PLANNING COMMITTEE - 3 JULY 2018

| Application No: | 18/00501/FUL | |
| Proposal: | Erection of a new detached dwelling and detached garage | |
| Location: | Land Adjacent Lime Tree House, Halam Hill, Halam | |

DIAGRAM A

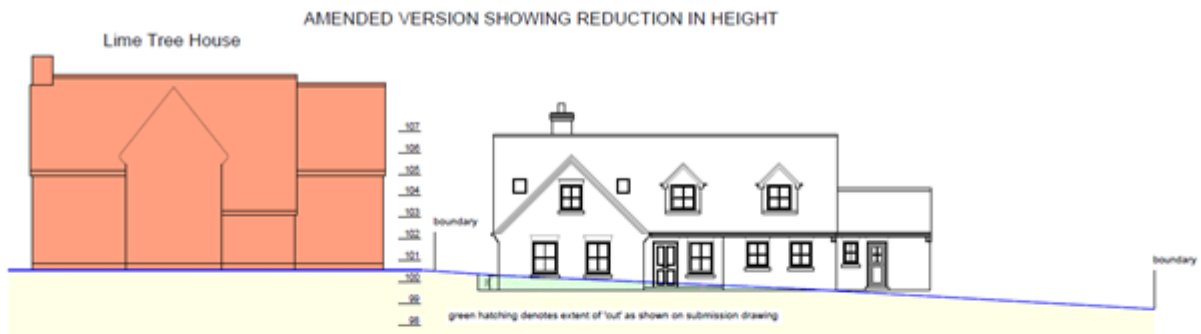
Diagram A shows a comparison between the block plan approved in 2016 and the currently proposed block plan.

DIAGRAM B

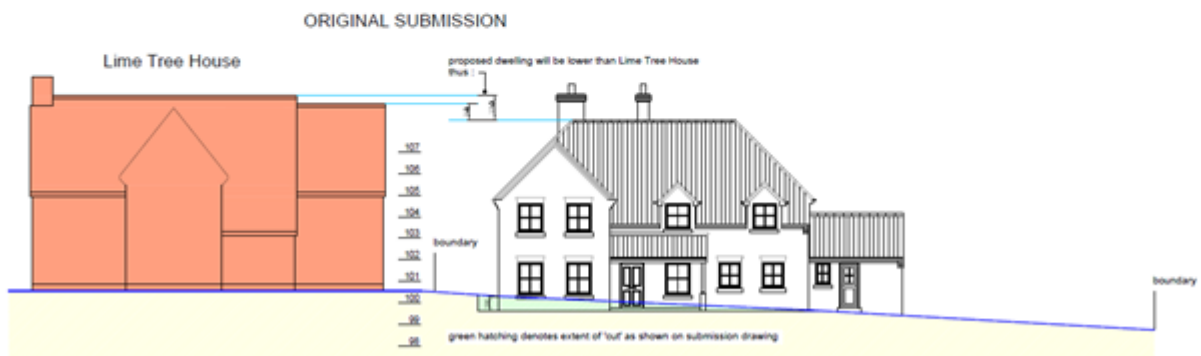
Diagram B below shows a comparison between the original proposal and the revised scheme with the reduced ridge height together with the streetscene drawing to include details as requested by members at the June Planning committee.

Thank you for sending through the revised elevation and street scene.

There would be no conservation objection to these revised plans.

By dropping the height the building has become a little ‘top heavy’ in pure design terms, but not so much that, given the appearance of the buildings in the immediate surroundings, it is noticeably incongruous.

The real heritage test here (as this is not a Conservation Area) is the impact on the setting of the nearby listed building. The revised design, while it would better if were less top heavy, is not in itself harmful to the setting of the nearby listed buildings, and I have already explained why the principle of development here is acceptable in terms of the setting of the listed buildings. I still remain of this view given the revised design.”
